# Access Compliance Report

## Public Rights-of-Way

### (Curb Ramps)

Intersection ID: 10033945	Main Street: PARK_RD	Cross Street: N/A	Location: SW
ADA ID: 5AEF111C783F	Ramp Type: Perp	Initial Pass/Fail: Fail	Overall Compliance: No
Severity Score: 12.5			
Codes/Mitigation Info/Possible Solution		Field Measurements/Component Compliance

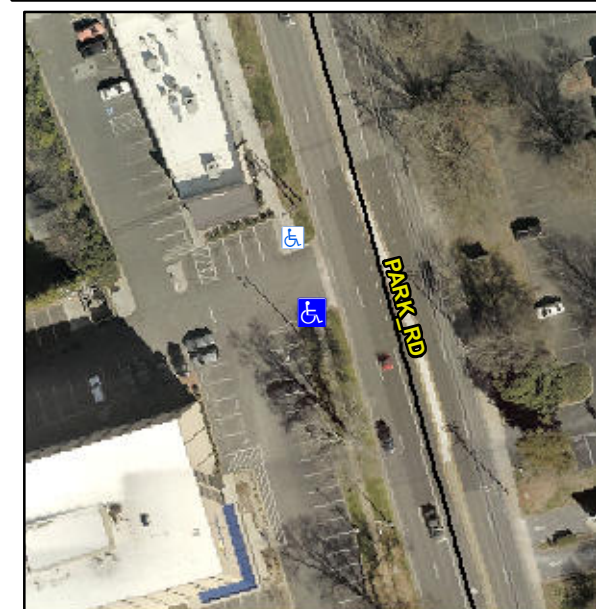
**Remove & Replace Entire Ramp.**

**R304.2.2**

Compliance	Description	Data	Compliance	Description	Data
N/A	Ramp Length (in)	120.0	No	Ramp Slope (%)	10.5
Yes	Ramp Width (in)	48.0	Yes	Ramp XSlope (%)	0.5
N/A	Flare Type LT	N/A	N/A	Flare Type RT	N/A
N/A	Flare Slope LT (%)	N/A	N/A	Flare Slope RT (%)	N/A
N/A	Flare Traversable LT?	N/A	N/A	Flare Traversable RT?	N/A
N/A	Landing Length (in)	N/A	N/A	DWS Provided?	N/A
N/A	Landing Width (in)	N/A	N/A	DWS Contrast?	N/A
N/A	Landing Slope (%)	N/A	N/A	DWS Length (in)	N/A
N/A	Landing X Slope (%)	N/A	N/A	DWS Full Width?	N/A
N/A	Landing Curb? (Y/N)	N/A	N/A	DWS Offset (in)	N/A
N/A	Shared Landing?	N/A			
N/A	Gutter Ponding?	N/A	N/A	Gutter Slope (%)	N/A
N/A	Gutter Lip Ht (in)	N/A	N/A	Gutter X Slope (%)	N/A
N/A	Painted X Walk1?	No	N/A	Painted X Walk2?	N/A
	X Walk 1 Direction	To N		X Walk 2 Direction	N/A
N/A	X Walk 1 Width (in)	N/A	N/A	X Walk 2 Width (in)	N/A
	X Walk 1 Slope (%)	0.7		X Walk 2 Slope (%)	N/A
	X Walk 1 X Slope (%)	4.4		X Walk 2 X Slope (%)	N/A
